1st Further Information

Proposed Temporary Public Vehicle Park (Excluding Container Vehicle) and Associated Filling of Land for a Period of 3 Years in "Agriculture" Zone', Lot 1475 S.B RP (Part) in D.D. 83, Lung Yeuk Tau, Fanling, New Territories

(S.16 Planning Application No. A/NE-LYT/884)

DWG. TITLE
SWEPT PATH ANALYSIS

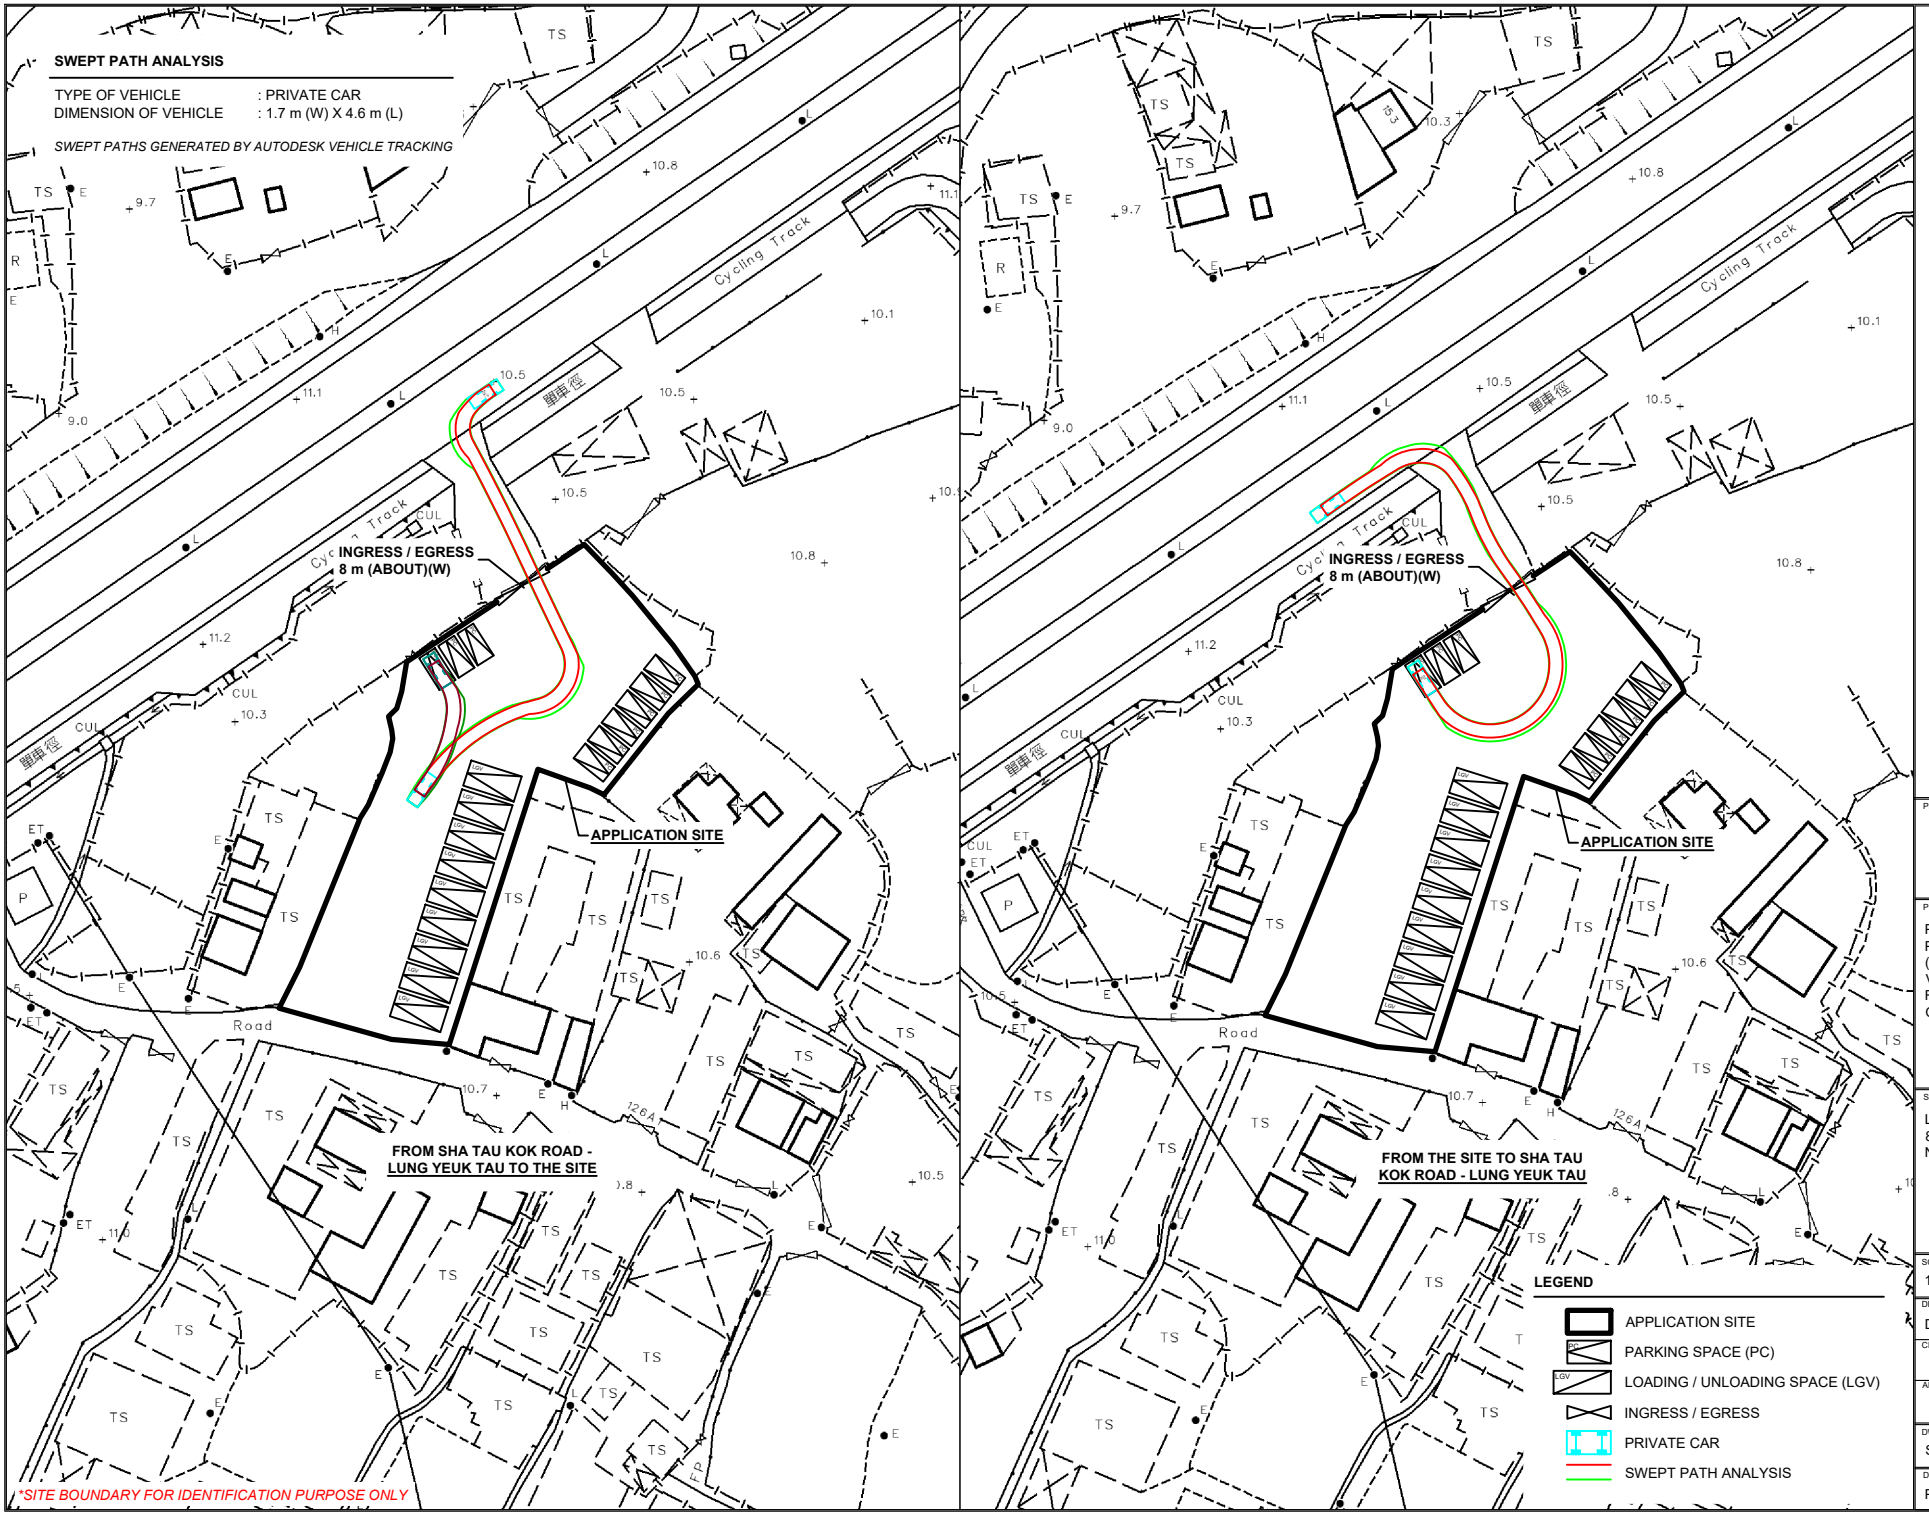
(2)	Please also supplement swept path analysis showing the satisfactory maneuvering of PC-type vehicles entering and leaving the Site.	Noted. Please find swept path analysis at **Appendix II**. The swept path analyses have demonstrated that sufficient spaces are provided for all vehicles to manoeuver when entering/leaving the Site.

LANDSCAPE PROPOSAL

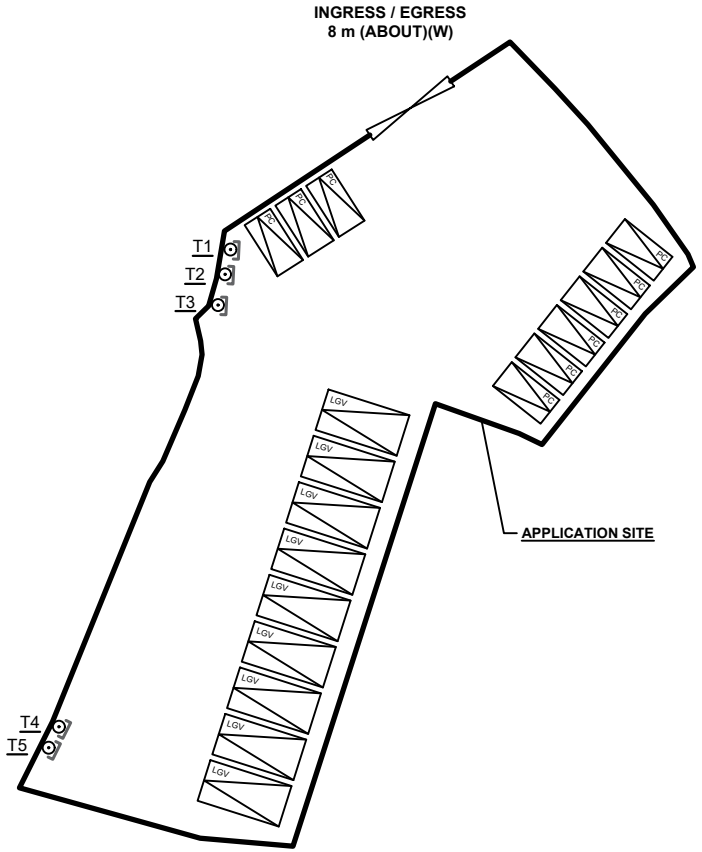
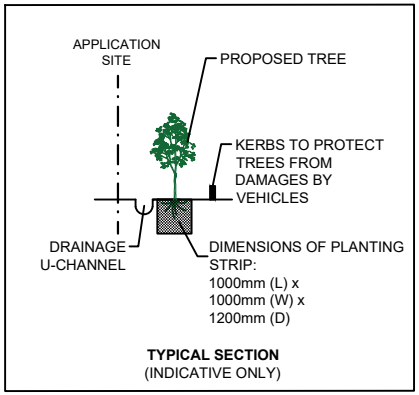
(1)	Regarding Drawing No. Plan 5, land filling of the whole site is proposed which may lead to tree felling. This contradicts with the Application Form which states that no tree felling will be involved. Please clarify.	Noted. According to a tree survey conducted by the applicant, 5 nos. of trees were identified within the site boundary. No OVT or protected species has been identified. Due to land filling in the Site, all identified trees are proposed to be felled. A landscape proposal is provided by the applicant (**Appendix III**) where 5 new trees (i.e.

Bauhinia Blakeana) (T1 to T5) are proposed to be planted at the southeastern portion of the Site as a landscape buffer. The proposed 5new trees will be planted at least 1.2m soil depth for better tree health. The new proposed trees are for mitigating any potential visual and landscape impact (if any) towards nearby sensitive receivers. The new trees planted within the Site will be maintained by the applicant in good condition during the planning approval period.
